UNITED STATES PATENT AND TRADEMARK OFFICE

10/520,935

Office Action Summary	Application No. 10/520,935	Applicant(s) NUMMINEN, MICHAEL	
	Examiner Harry Liu	Art Unit 3662

DETAILED ACTION

FIG. 8

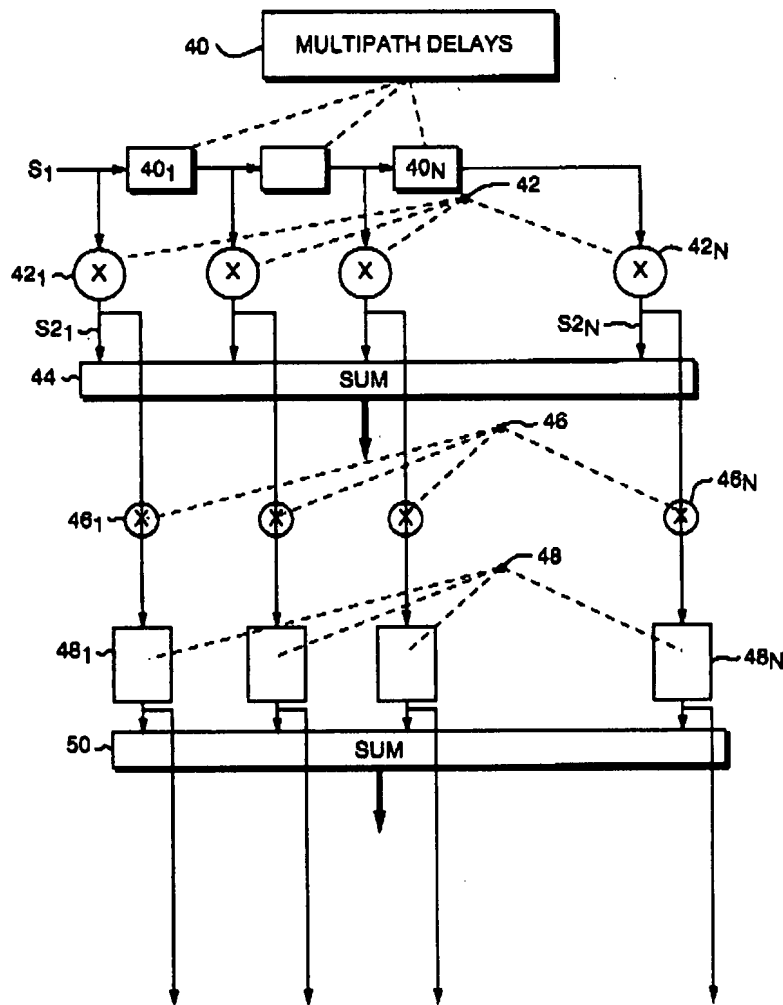
Robbins does not specifically disclose the method of saving the radiation diagram at t_1 and t_2 ; switching off one element at a time and keeping the ends remain, it is known for people skilled in the art that weighting is a method of combining (summing) gain, phase and time interval (for multipath purposes) from all array elements by reducing /turning off some elements based on weight. Plus, Fletcher teaches turning off antenna element (column 7, lines 27-32). It would have been obvious to modify Robbins by Fletcher by taking radiation diagrams from different time intervals (t_1 and t_2); turning off (or reducing) one array at a time (which is in between ends falling on side lobes) in order to get an antenna system that is capable of receiving signals more from main lobe instead of side lobes and capable of finding the maximum distance between element without seeing grating lobes.

FIG. 9A

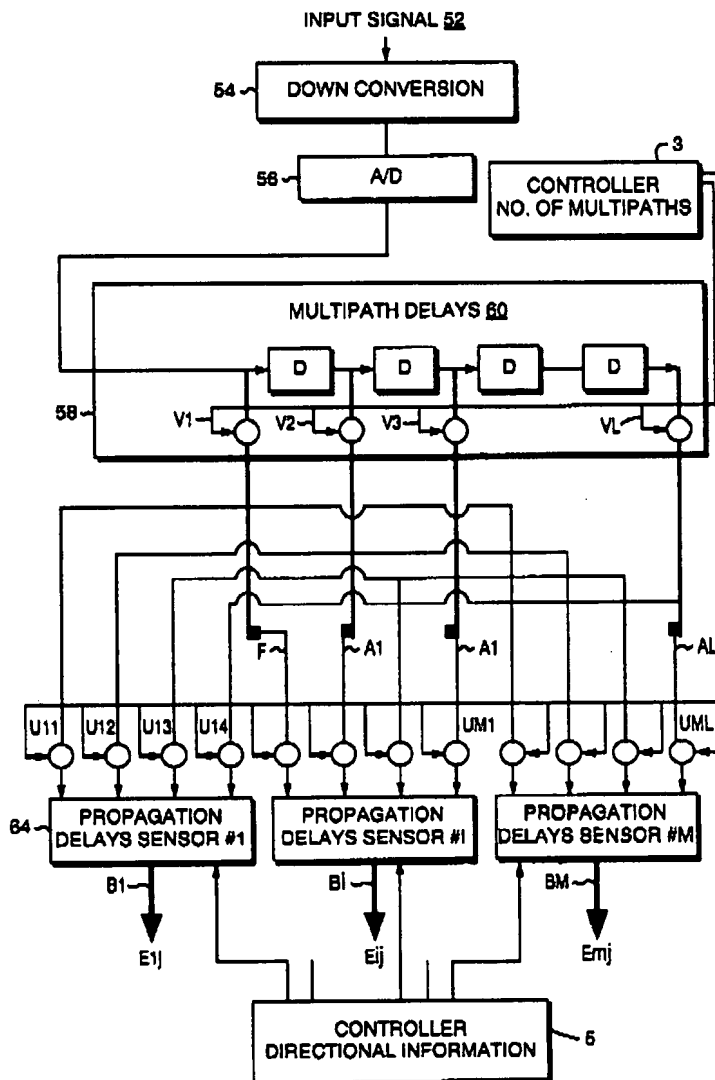
direction in which the array has maximum gain (column 7, lines 15-25). This is finding the maximum point for the corresponding angle on main lobe. The A/D converter for converting analog to digital is used (see Fig. 9A below) for converting analog signals to digital signals.
